Narrative Testimony for the M3 Eagle Water Right Application

Dennis Owsley

May 11, 2009

This narrative testimony was developed in response to the April 1st memo prepared by HLI in response to our March 2nd Staff Memorandum. I co-authored the March 2nd Staff Memorandum and appreciate this opportunity to provide testimony in response to the comments provided by HLI in the memo.

Cross Section 4

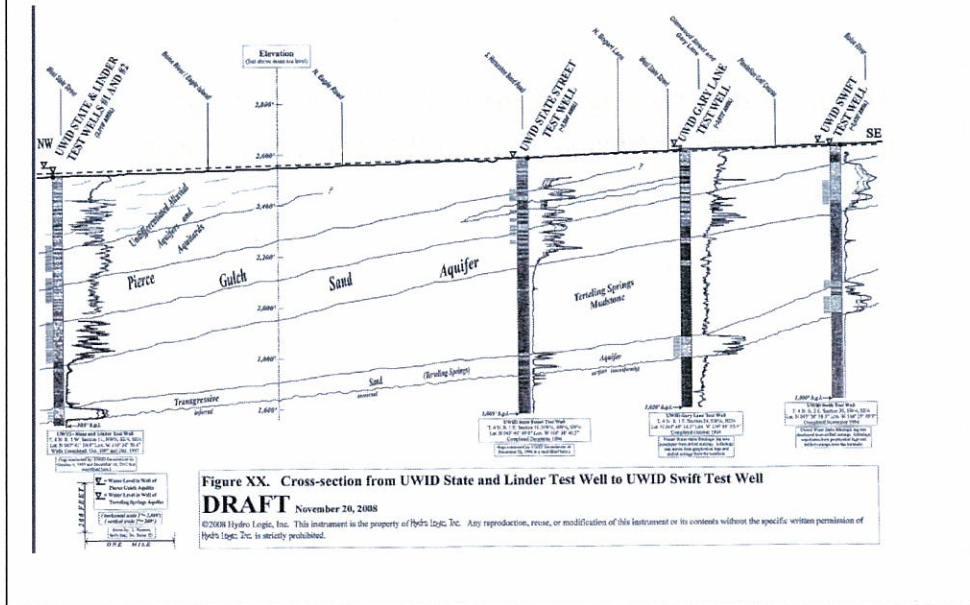
This slide shows one of the submitted cross sections developed by HLI in exhibit 26. With respect to PGSA exposure under the Boise River, HLI states on page 28 of Exhibit 45 that the geophysical signature of the Swift well represents the PGSA 400 feet beneath the river. According to this figure, the PGSA is depicted from approximately 75 feet to 225 feet below the Boise River. This inconsistency questions the certainty of identifying this interval of this well as PGSA. In addition, the region identified as the PGSA in the two central wells of this diagram is not distinguishable from the undifferentiated alluvial aquifers and aquitards in the upper left section of this diagram.

Exhibit 44
Figure 46

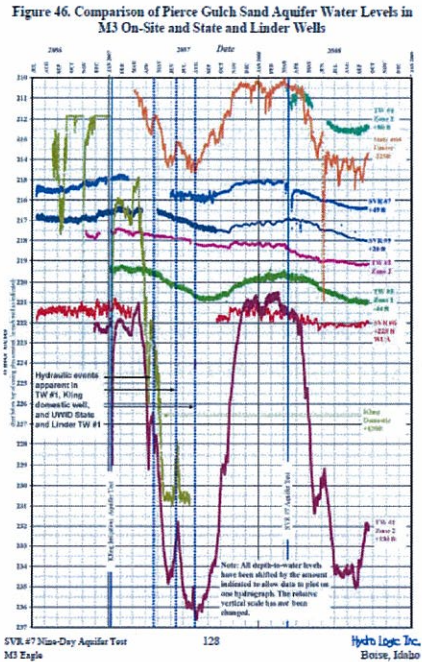
First, I would like to point out four wells that all show a similar downward trend over the past three years of monitoring. The wells are SVR #7, SVR #9, TW#2, and TW#3. They are the two blue plots and the pink and green plots on the graph. These wells are all located in the central A close visual inspection of the water levels from these four wells on the M3 property shows a declining trend over the past few years. This trend is interesting, considering the testimony that water levels are rising down in the valley in wells believed to be completed into the same aquifer.

Next, I'd like to point out two more wells on this graph. The wells are United Water State and Linder Test Well and the Tw#1. These wells are represented by the orange plot (the united water well) and the maroon plot (TW#1) on the graph. Notice the significantly different seasonal water level fluctuation exhibited in these wells when compared to the first four. TW#1 is located down in the southwest portion of the "panhandle" section of the property. United Water State and Linder well is located near the intersection of State Street and Linder Road. The department noted this change in water level fluctuations in the staff memorandum and HLI responded on Page 20 of Exhibit 45

The staff did not ever imply that the two groups of wells were in separate geologic units. This difference in fluctuations does not support HLI's claim that the fluctuations are due to the proximity of the pumping centers, or one would expect the State and Linder monitoring well would have a greater response to such pumping than TW#1. The response by HLI is not supported by the data presented Figure 46, as the seasonal fluctuations in the State and Linder (closer to the pumping wells) are approximately five feet, whereas the same seasonal fluctuations in TW#1 are on the order of 16 feet.

Figure 1

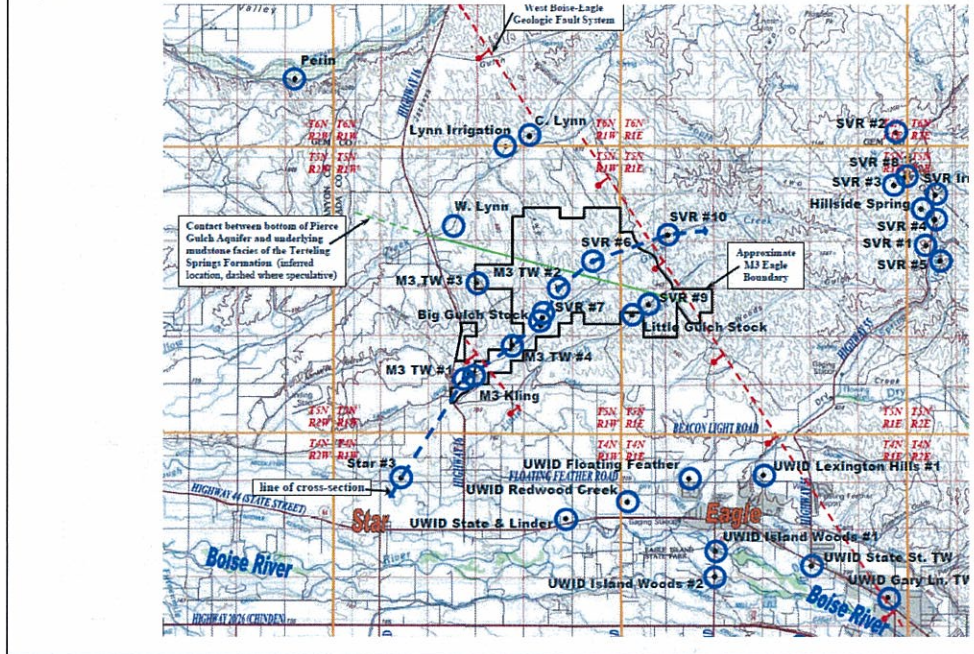
First, we heard testimony from Mr. Glanzman that the TDS values in the Pierce Gulch ranged from approximately 80 mg/L to over 400 mg/L. He later testified that the low TDS value indicate you are near a recharge zone. The lowest TDS value from PGSA wells came from the State and Linder Well, which is tens of miles from the speculated recharge area. The location in which the State and Linder well is located is defined as a discharge area for the PGSA by HLI, an inconsistency in the conceptual model and the geochemical results.

It does not appear that many (or any) shallow, non PGSA identified wells were sampled and analyzed. The analysis of the overlying aquifers when compared to the PGSA analysis would provide information related to the interconnectivity between the aquifers.

Figure 27

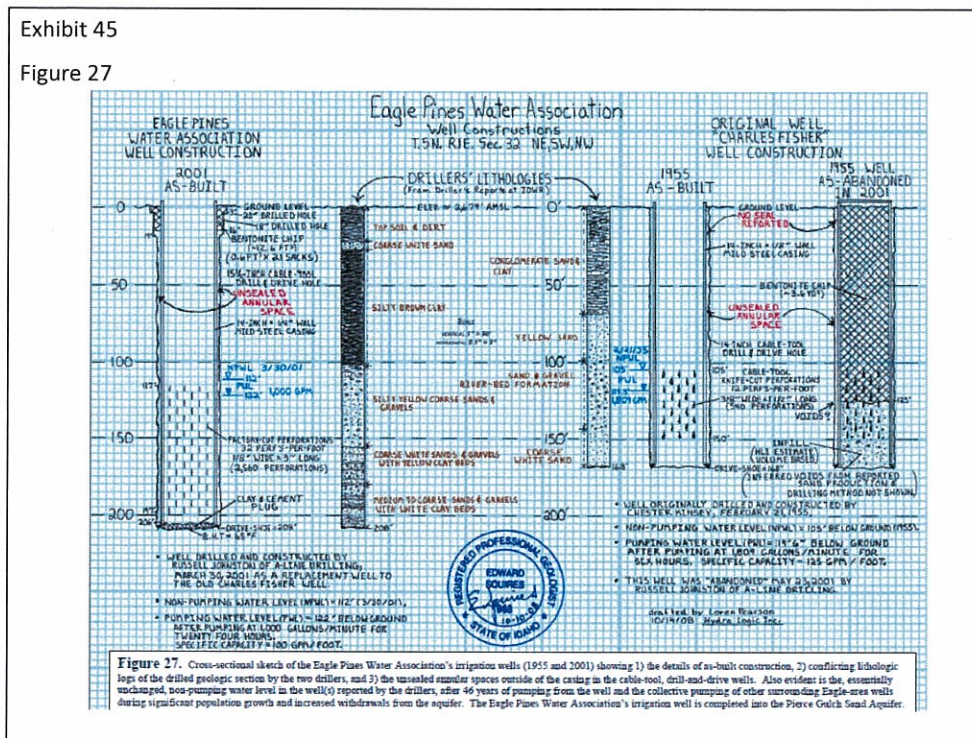
This slide shows figure 27 of Exhibit 45. This figure depicts the Eagle Pines Water Association old and new irrigation well diagrams. Note the annular seal on the both wells is identified as “Unsealed Annular Seal”.

By referring to the water levels in this well that is identified by Mr. Squires as unsealed, HLI is not consistent with their previous statements regarding the use of data from unsealed wells.
